# T ECHNICAL INFORMATION

70955

- Subject** ▶ Change of Guide Plate
- For Models** ▶ LS1013, LS1013F
- Country** ▶ All countries
- Description** ▶ Guide plate has been modified as illustrated below.

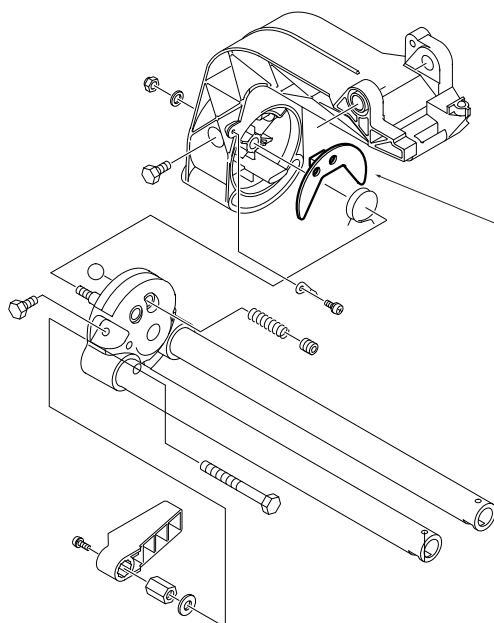
▶ Current	▶ New
<p>Guide plate (344414-6)</p>	<p>33.90 degrees A hole for positive stopper has been added.</p> <p>Guide plate (345418-1)</p>

Item No.	Current part		Q'ty	I/C	New part		Q'ty	Note
100	Guide Plate 344414-6		1	←	Guide Plate 345418-1		1
